Re: Site Plan Revisions
407-419 Mapleview Drive West
City of Barrie, County of Simcoe

Modifications proposed within Site Plan (dated January 5, 2022)

CONCEPTUAL SITE PLAN - 46 Units

407 - 419 MAPLEVIEW DR. W - BARRIE

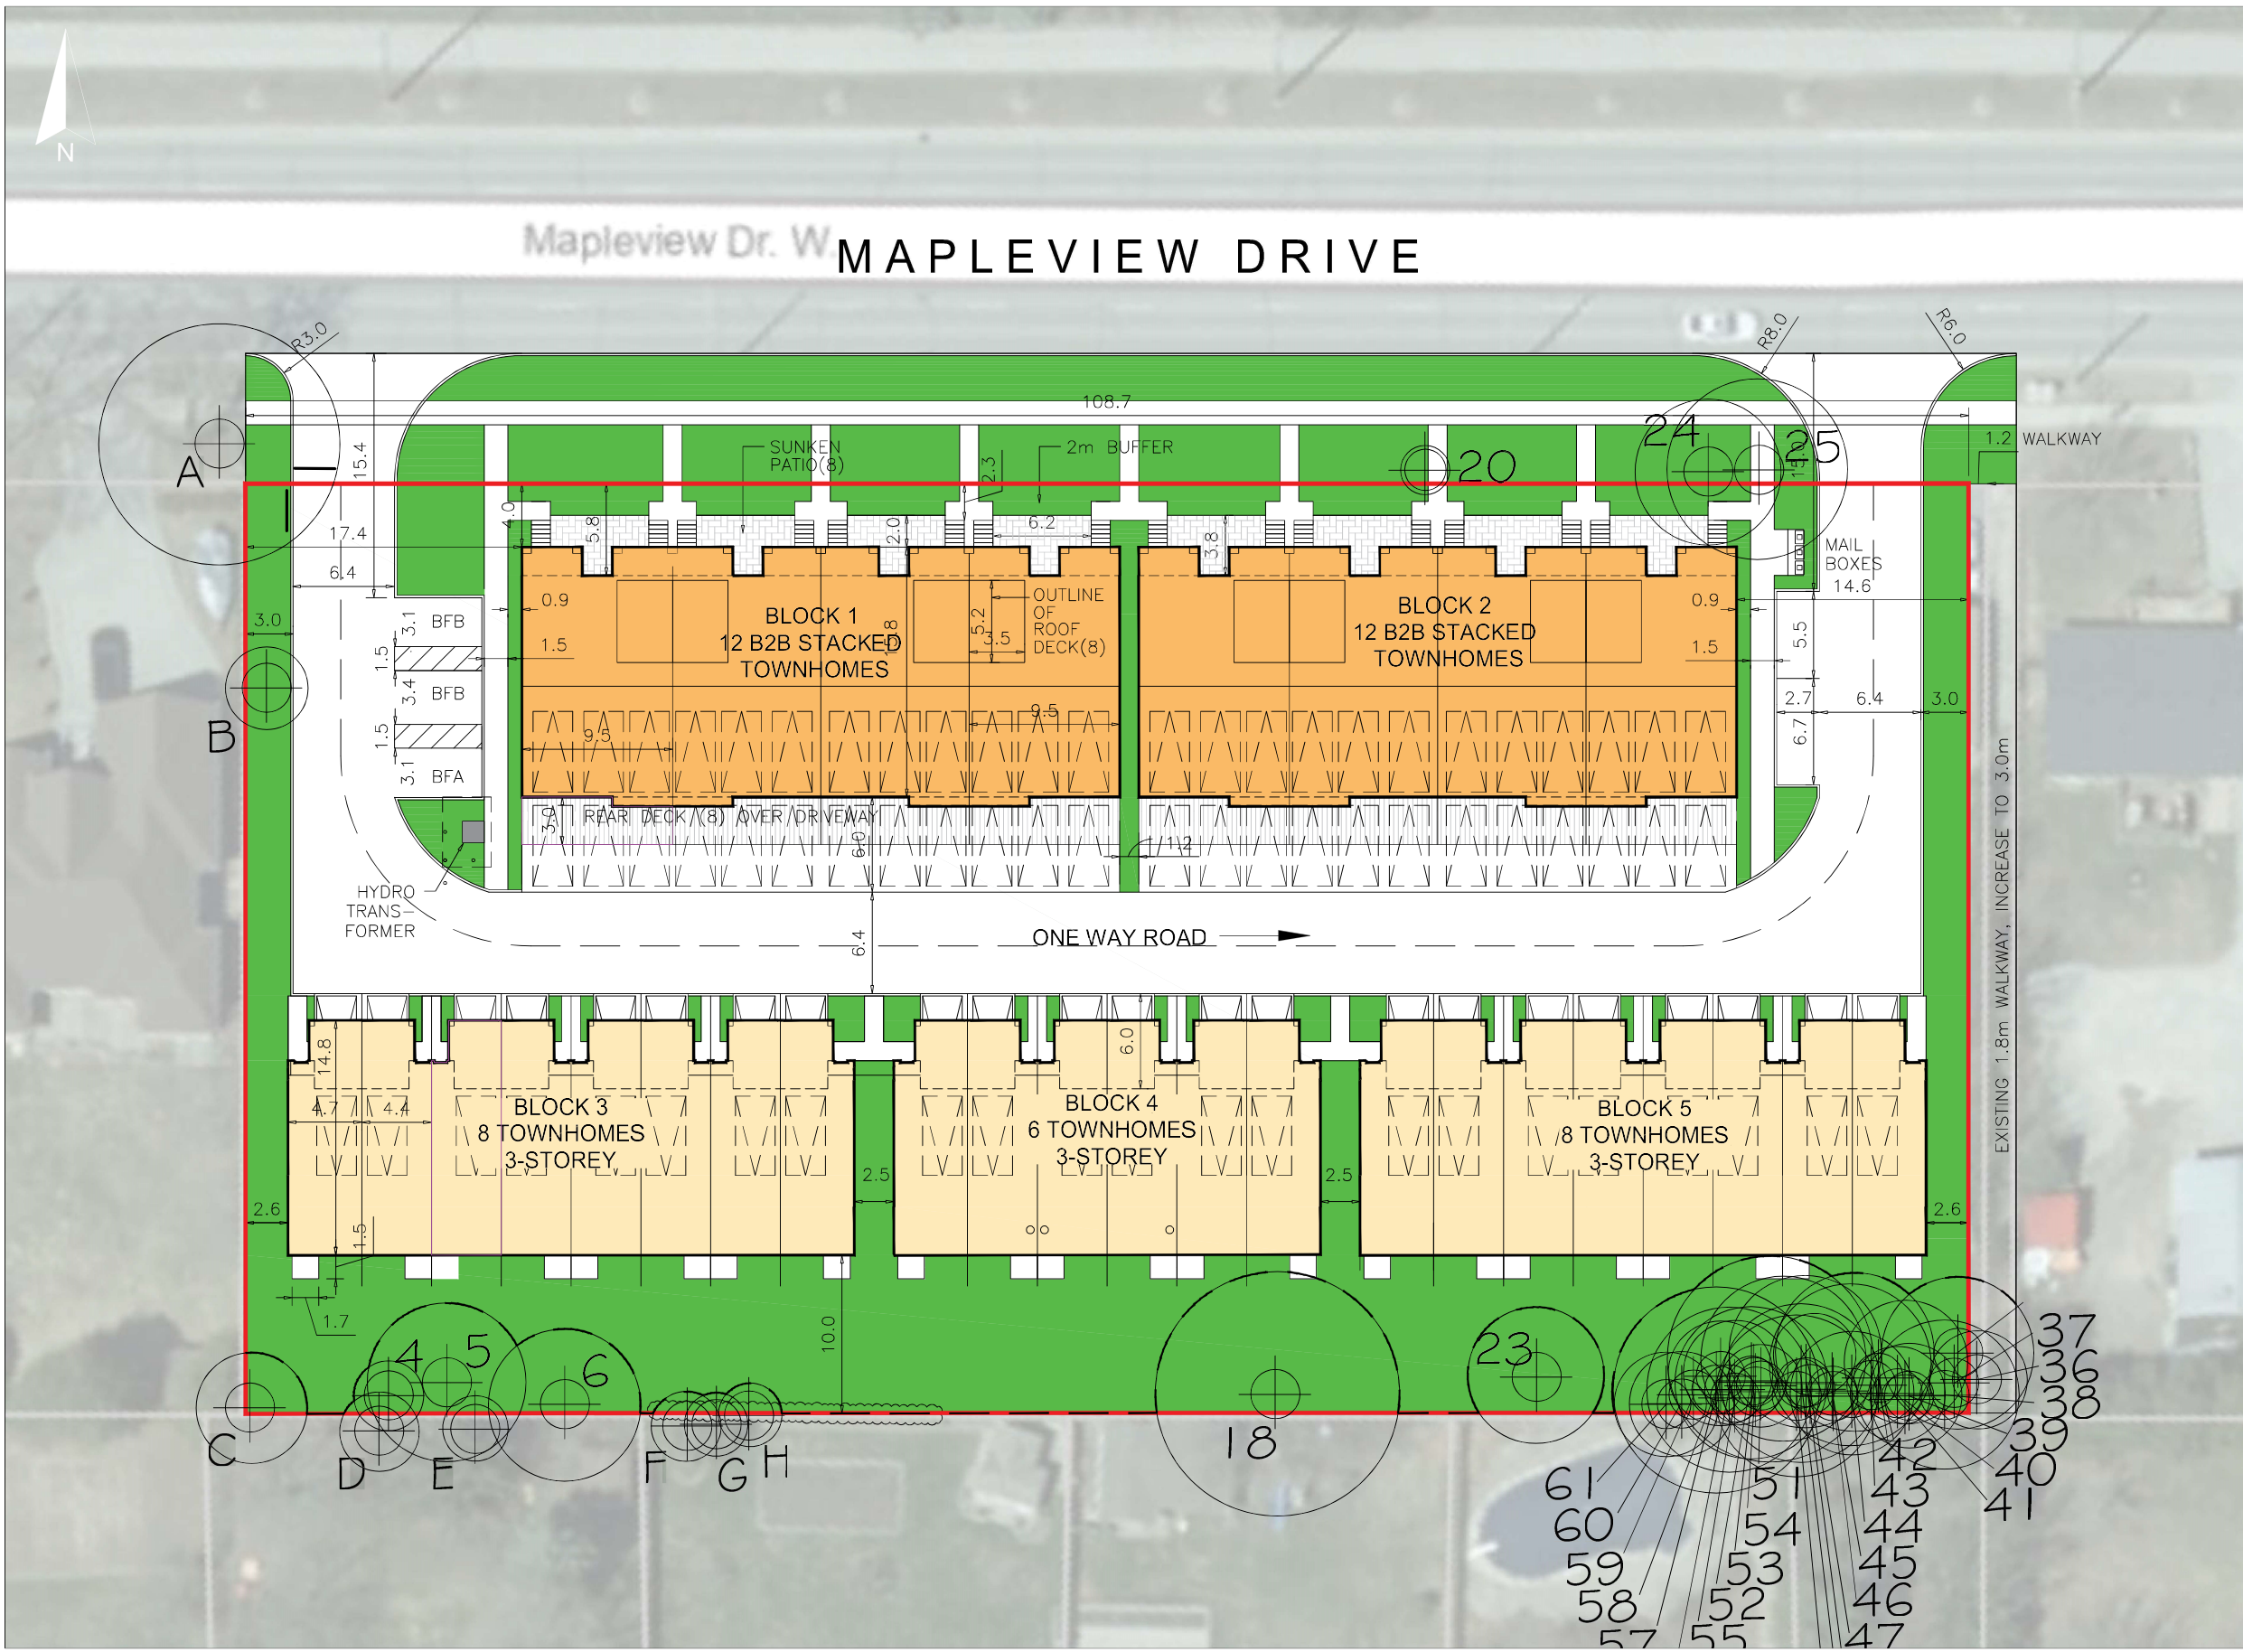
- 1. Eliminate Second Driveway Space for stacked townhouses** – the stacked townhouse driveway length has been reduced from 11.0m to 6.0m for units fronting Mapleview Drive. Rather than providing 2 driveway parking spaces, 1 driveway parking space is now provided for these units. This revision allows for the rear yard setback for the traditional townhouse units backing onto Redfern residents to be increased well above the requirements in the Zoning Bylaw. The removal of the parking space also provides the opportunity to increase the size of the traditional

2. **Rear Yard Setback** – the proposed rear yard setback has been increased from 7.0m to 10.0m. According to our professional arborist, this 10 metre setback provides sufficient space to protect rear yard tree's and increase privacy for Redfern residents.

3. **Rear Yard Decks on Traditional Townhouse Units** – for the traditional townhouse units, the proposed Zoning Bylaw Amendment text has been updated to include, "a maximum second storey rear yard deck area of 2.55m² (1.5mx1.7m) along with a minimum rear yard setback of 8.5 metres, per traditional townhouse (Blocks 3, 4, 5)". This provision ensures that the traditional townhouse decks are limited in size restricting the potential use of this space, further ensuring privacy for Redfern residents is maintained.

5. **Traditional Townhouse Unit Size/Depth** – the depth of the traditional townhouse units has slightly increased, providing townhouses that are now approximately 1,850 square feet.

6. **Stacked townhouse decks reduced** – due to the change in driveway length noted in item #1 above, the decks over the parking area have been reduced. They are now approximately 28.5 square metres per unit. The zoning requirement for this outdoor amenity space is 12 square metres per unit.

No.	Date	Description	By
1	Sept 15, 2021	Create final conceptual plan	J.V.
2	Sept 30, 2021	Issued for review	J.V.
3	Oct 7, 2021	Revisions based on comments	J.V.
4	Jan 5, 2022	Increase rear yard depth by revising driveway length of Back-to-Back towns;	A.S.
